GENERAL APPLICATION

The applicant is responsible for obtaining the appropriate	City Commission							
checklist for each type of	Explanation of Request: FINAL TAC REVIEW							
application.	Amendment to approvals O-2015-16 and R-2015-230							
Applicant(s) or their authorized legal agent must be	Number of units/rooms: 248 UNITS Sq Ft: 511,620 SF							
present at all Board or Committee meetings.	Value of Improvement: Estimated Date of Completion: JULY 2026							
ooninintee meetings.	Will Project be Phased? () Yes (X)No If Phased, Estimated Completion of Each Phase							
At least one set of the								
submitted plans for each	Name of Current Property Owner: 1817 TAYLOR ST DEVELOPMENT, LLC							
application must be signed and sealed (i.e. Architect or	Address of Property Owner: <u>1212 NW 82ND AVE, DORAL, FL, 33126</u>							
Engineer).	Telephone: 305-400-1397 Fax: Email Address: aensinck@me.com							
	Name of Consultant/Representative/Tenant (circle one): SANTIAGO TERAN

TECHNICAL ADVISORY SUBMITTAL: JULY 3RD. 2023

July 5, 2023

LAN	TING PLAN	: PRELIMINARY
R	LP-101	STATUS
CT R	13778.00	STA

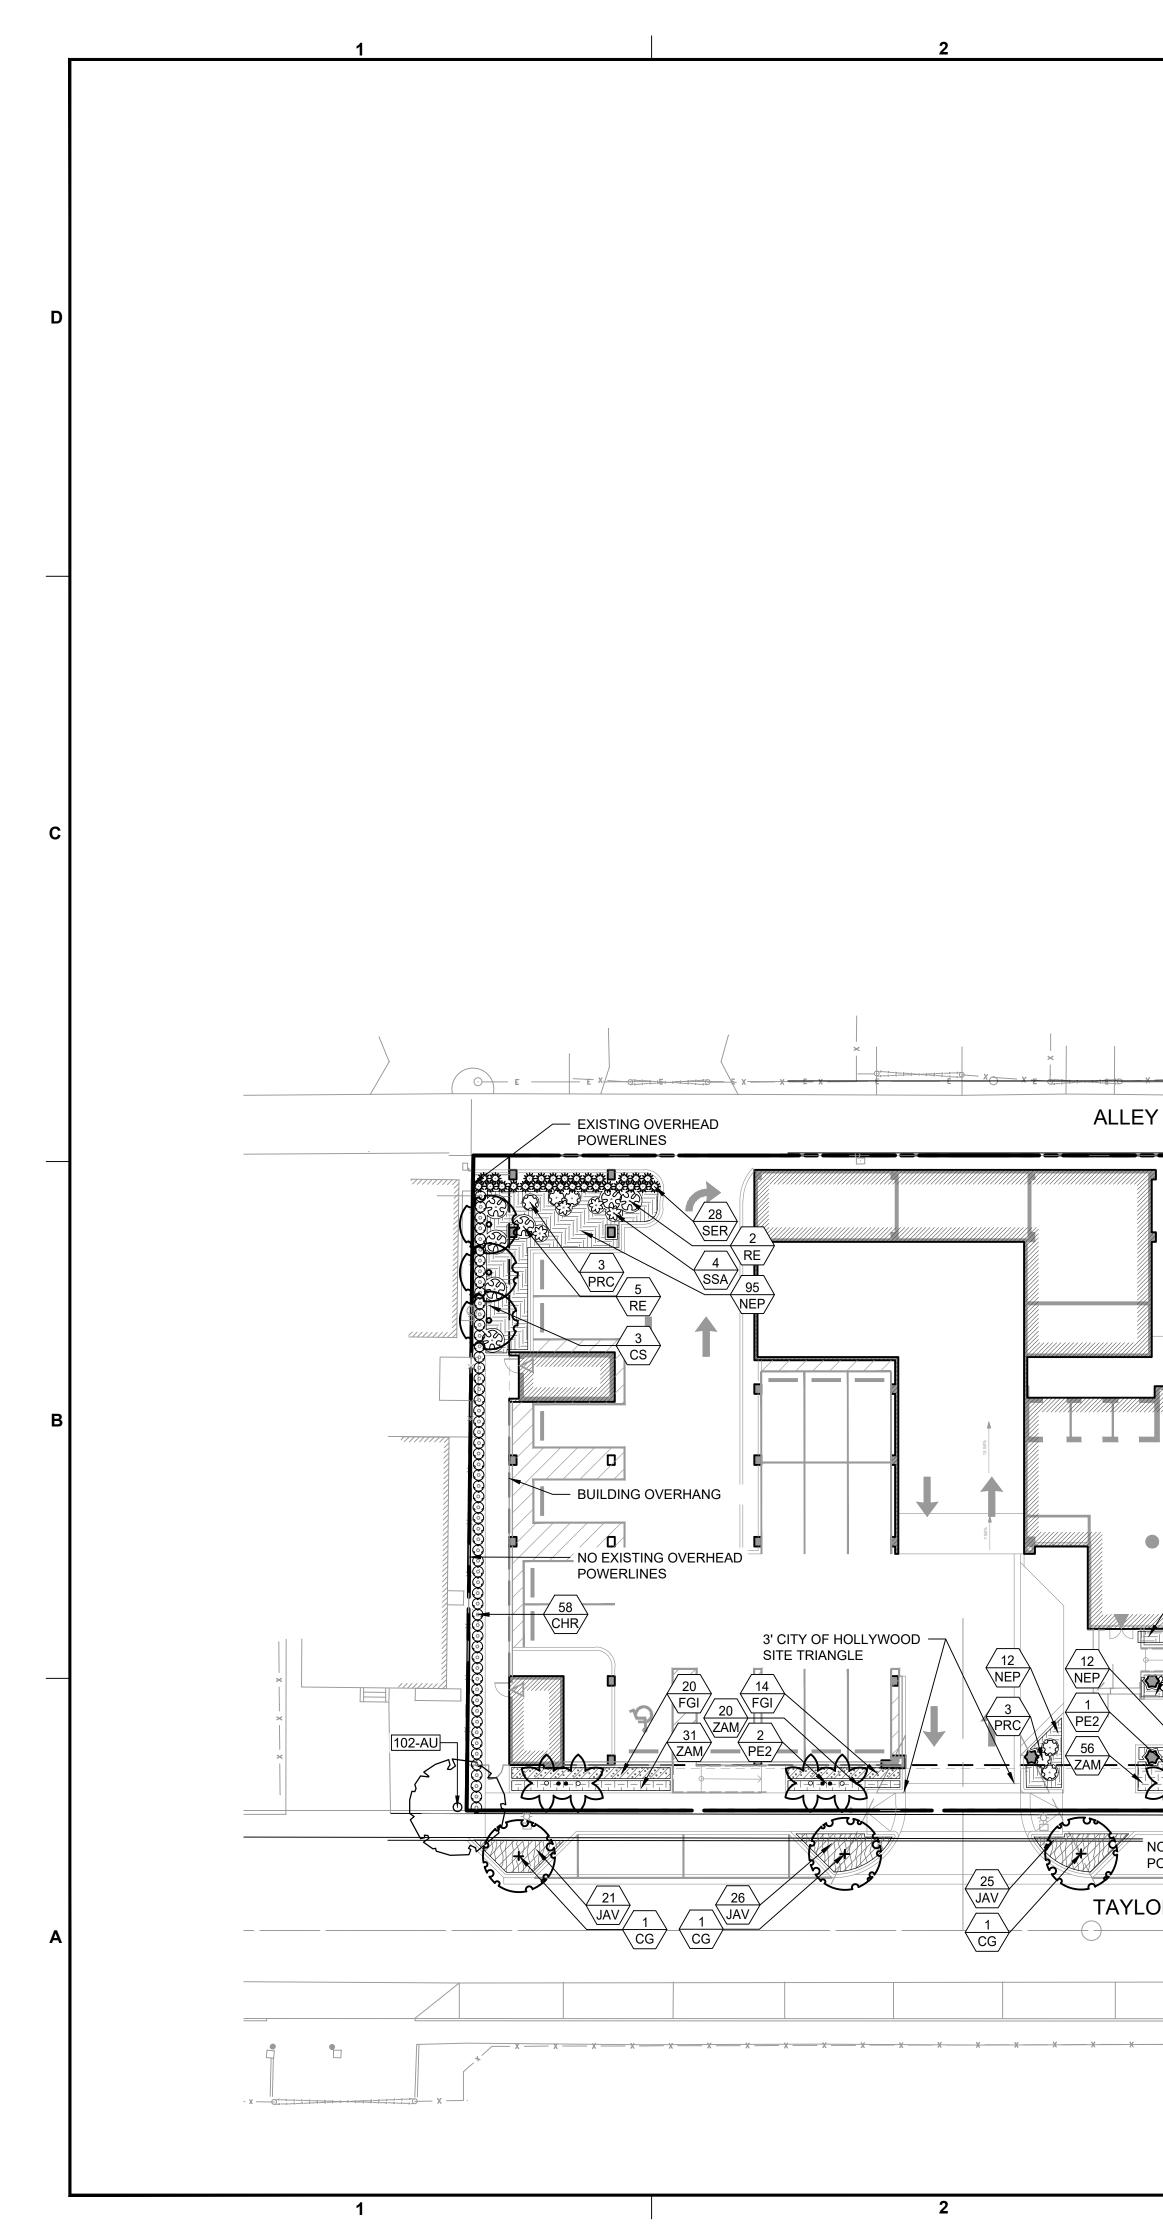
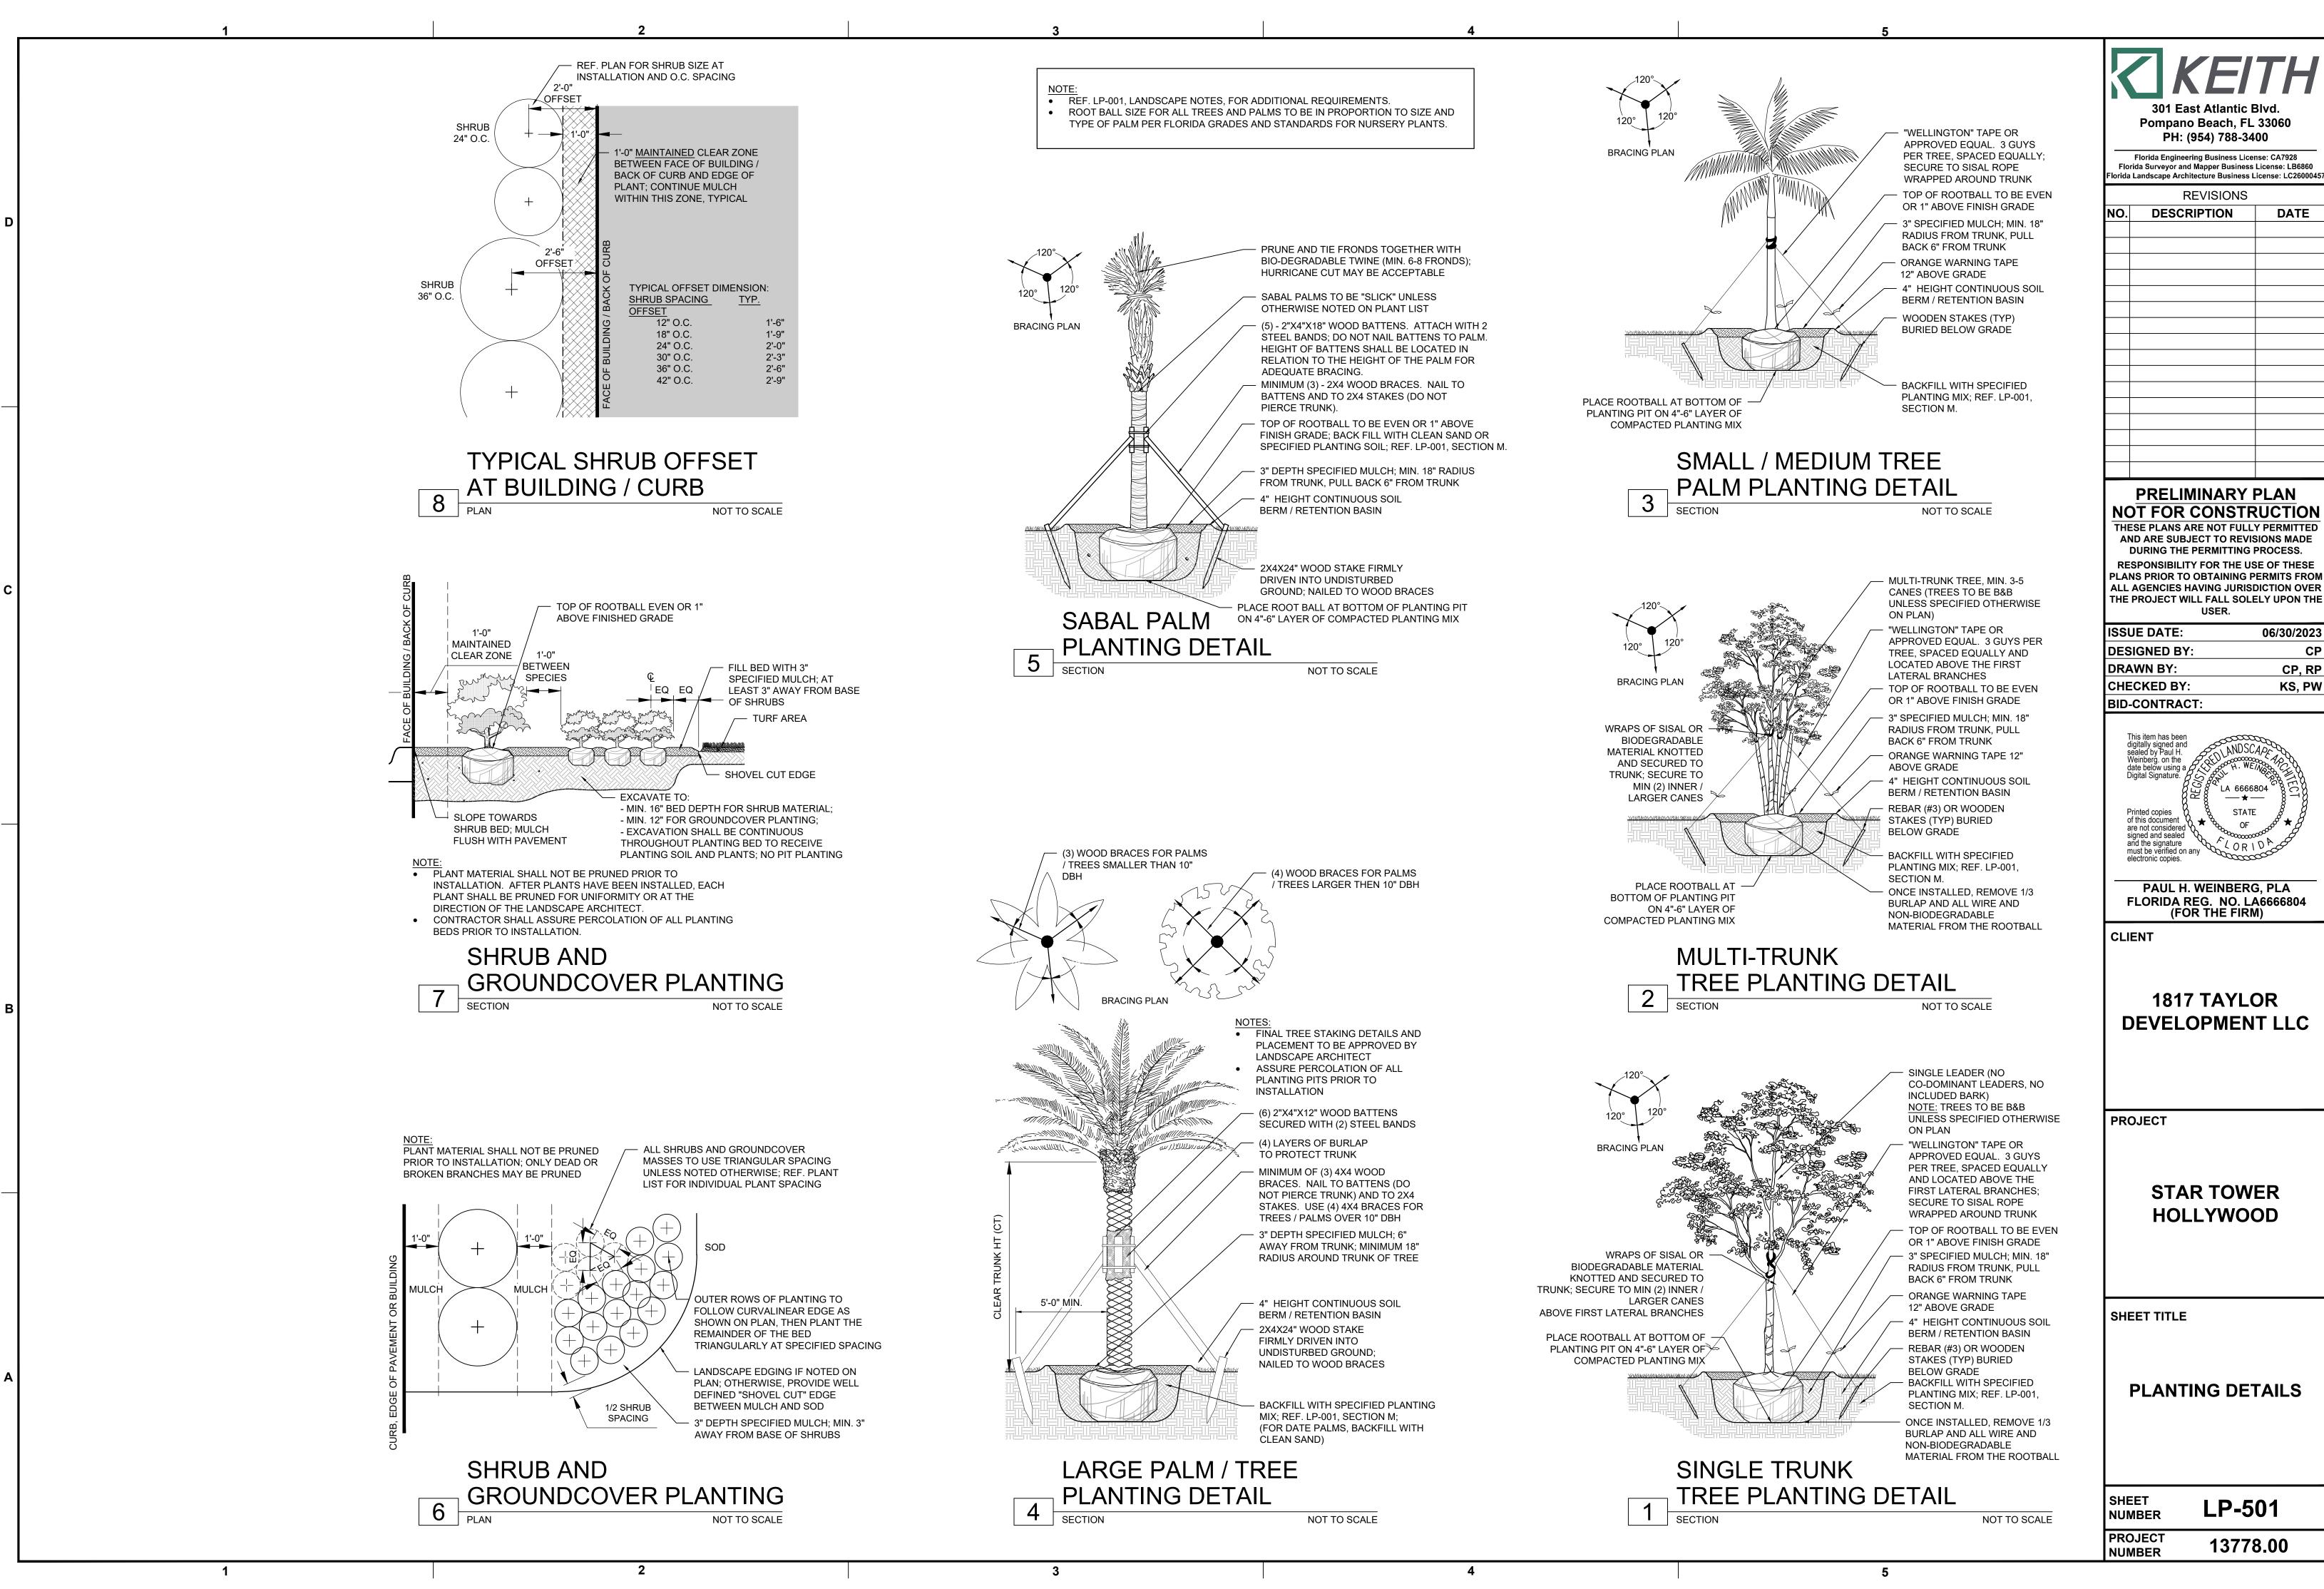
- a. Counts in the Parking Schedule do not match counts on the Site Data table. RESPONSE: Please refer to the new Site Plan, sheet SP-101.
- Multiple sections in the "Amendment to PD" section are blank and need to include the proposed change between the previously approved and proposed developments.
 RESPONSE: See updated Zoning Table on she SP-101
- c. The data table contains a calculation for the retail that contradicts the site plan. Revise accordingly.
 RESPONSE: Please refer to the updated Site Plan, sheet SP-101
- 10. Work with the City's Landscape Architect to ensure that all landscape requirements are met.

RESPONSE: Comment Acknowledged. Please refer to the provided Landscape Plan, Sheet LP-101. Landscape Plan to be reviewed by the City's Landscape Architect / Landscape Reviewer.

RESPONSE: Please refer to Sheet LP-101 which includes the civil utilities overlaid to visually verify utilities have been coordinated.

SHEET TITLE	
		EROSION CONTROL PLAN	PRELIMINARY
		SHEET CP-101	ATUS:
		PROJECT 13778.00	ST.

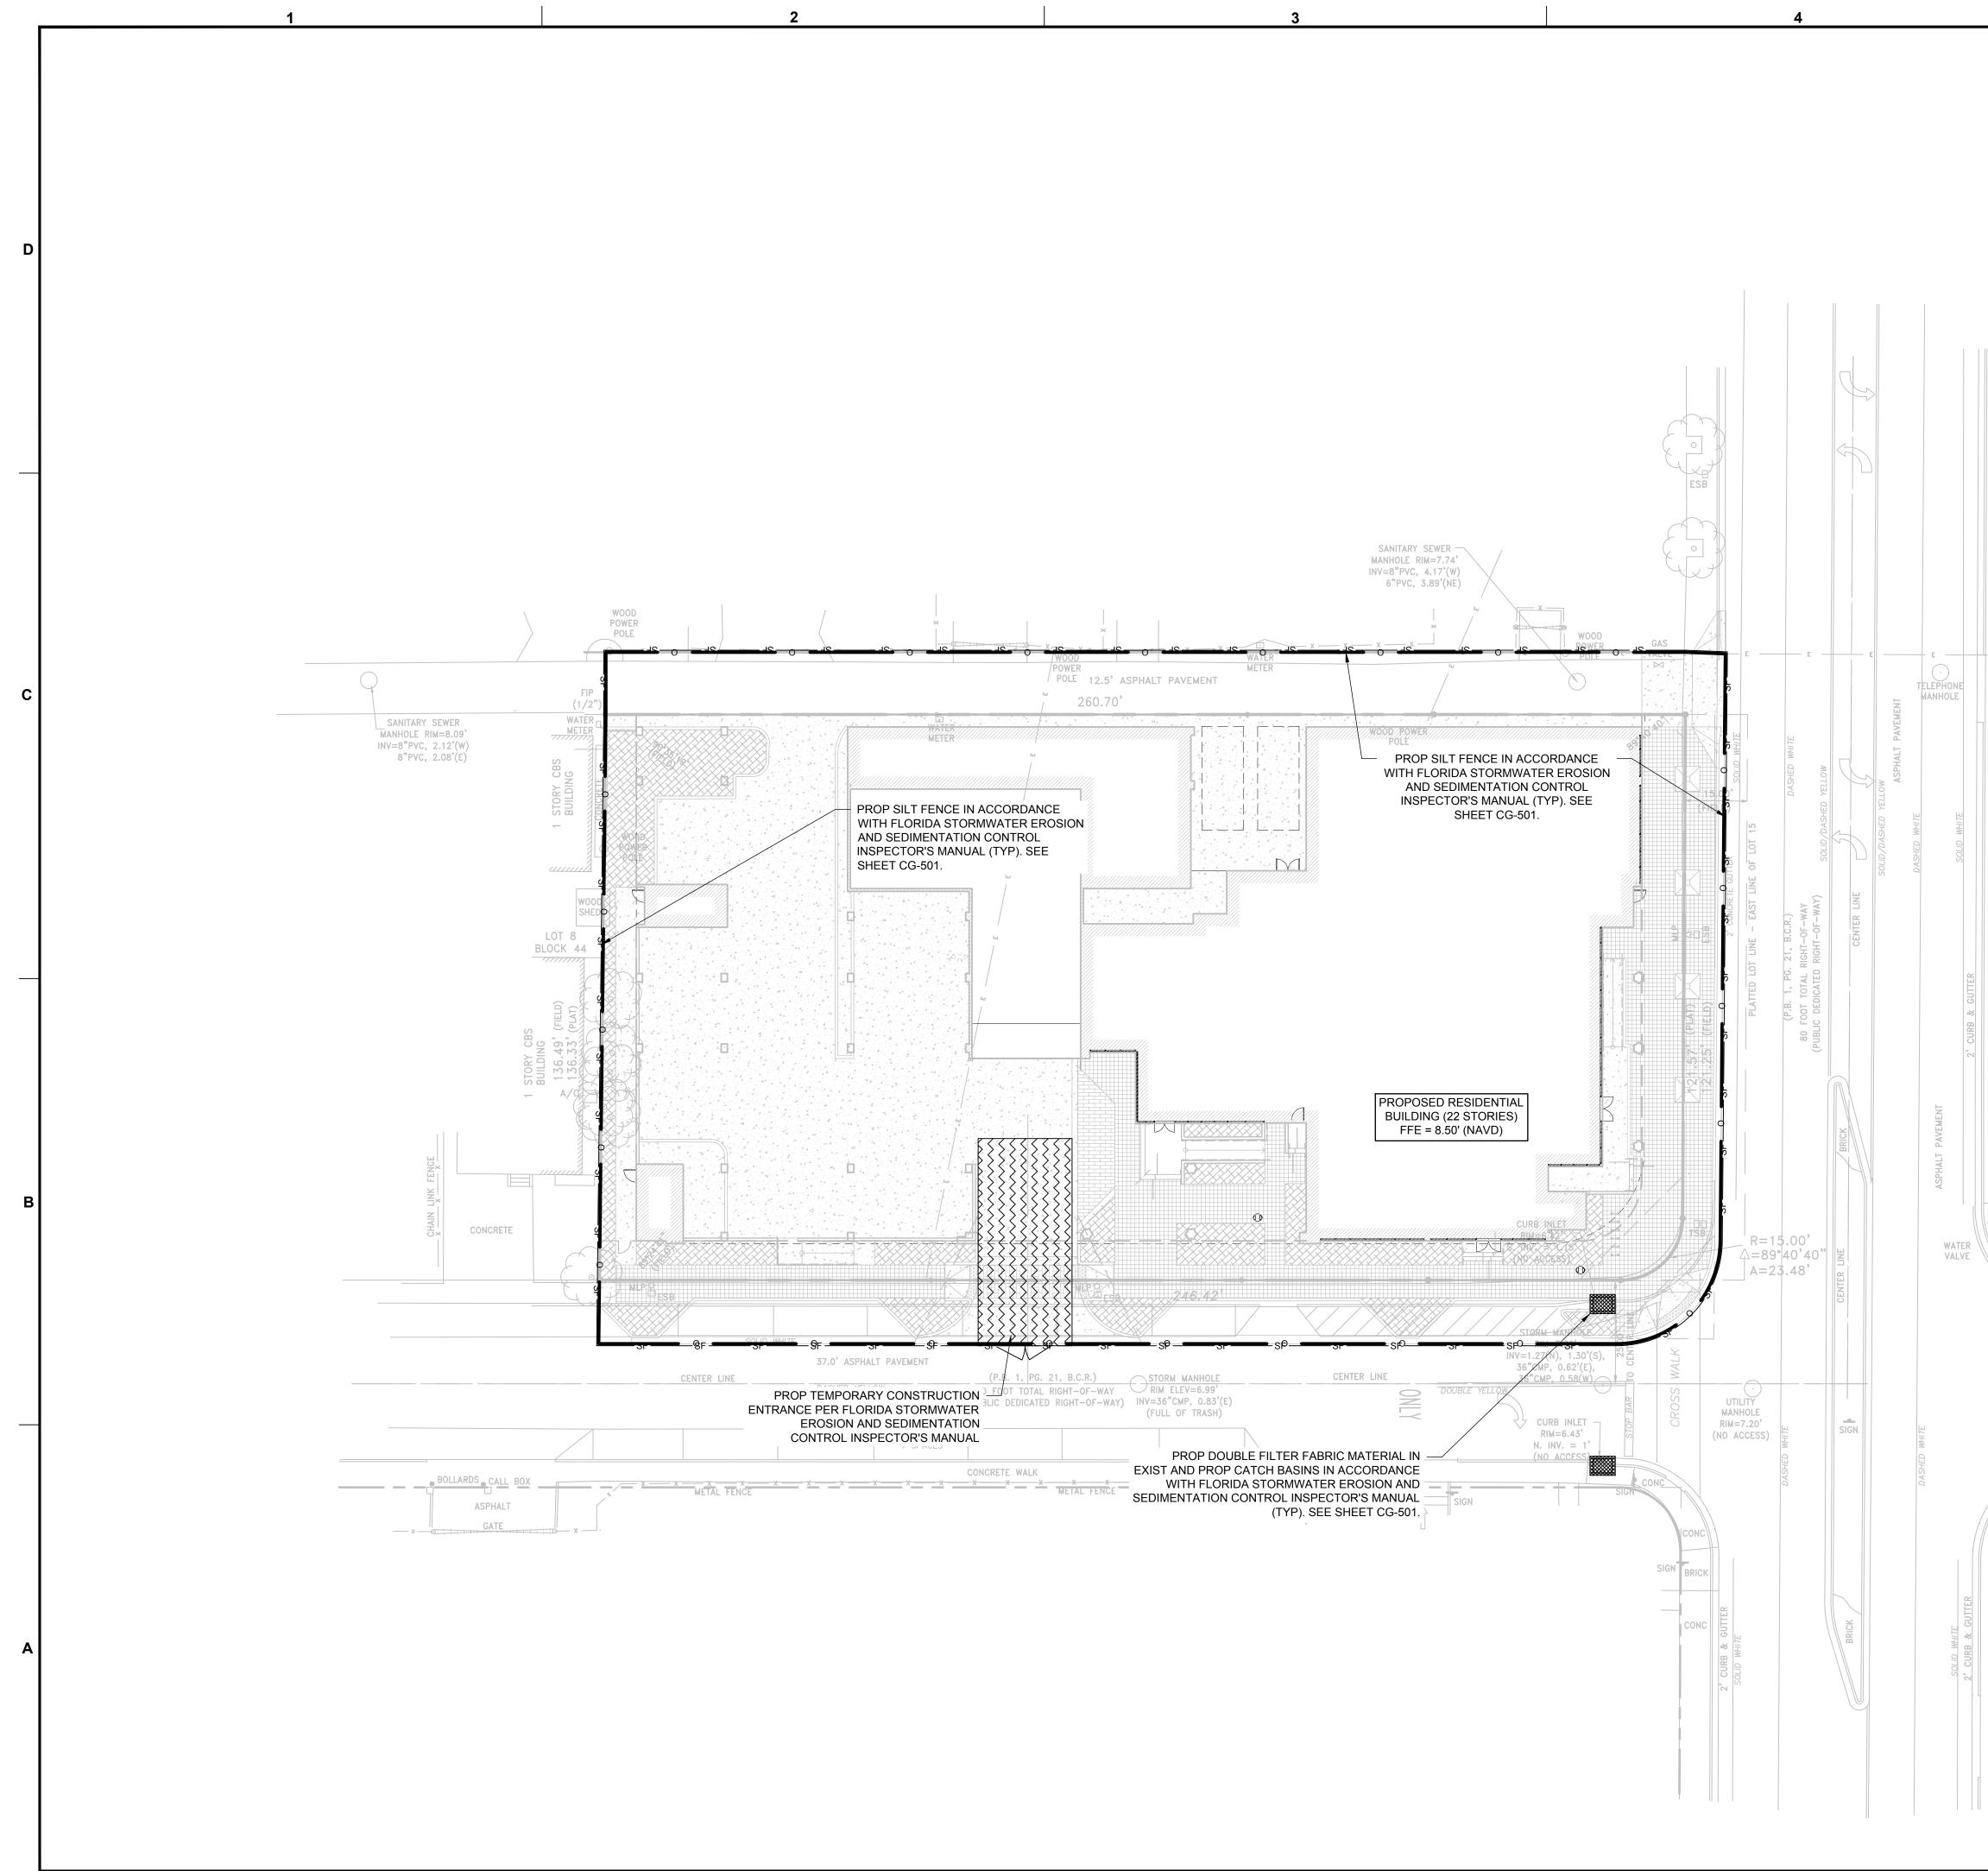
- 11. Submit Erosion Control Plan and details. RESPONSE: Refer to Sheets CG-101 through CG-501 for Erosion Control Plan and Details.
- 12. Permit approval from outside agencies will be required. RESPONSE: RESPONSE: Comment Acknowledged.
- 13. Landscape plans to be submitted should coordinate with civil plans to accommodate for drainage features.
